Re: Docket number 10-BSTD-01

October 13-14, 2011 Staff Workshop – 2013 Building Energy Efficiency Standards

Addendum B
ASHRAE Climate Zones Map

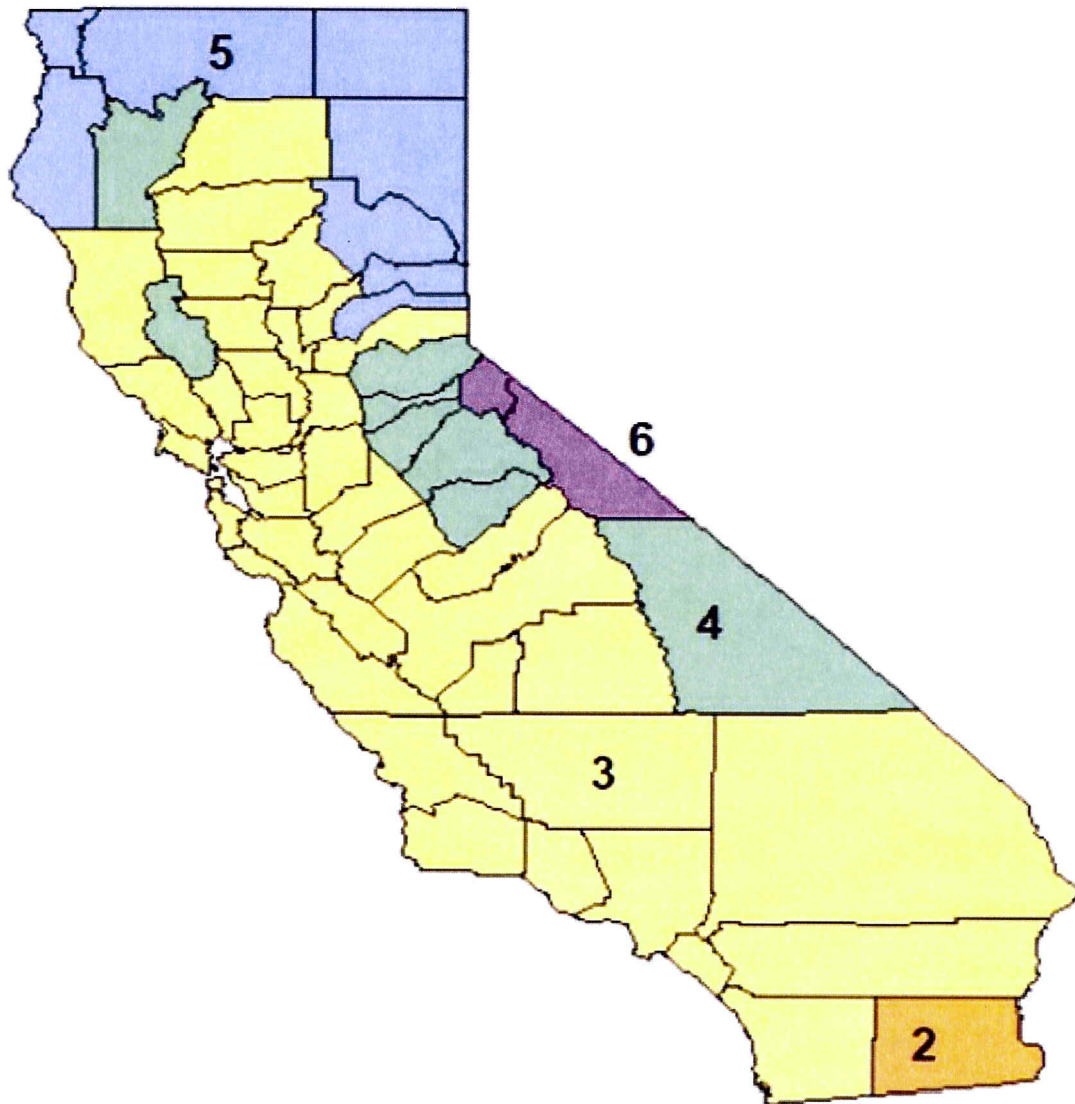
³ A map showing the climate zones used by ASHRAE is attached hereto as Addendum B.
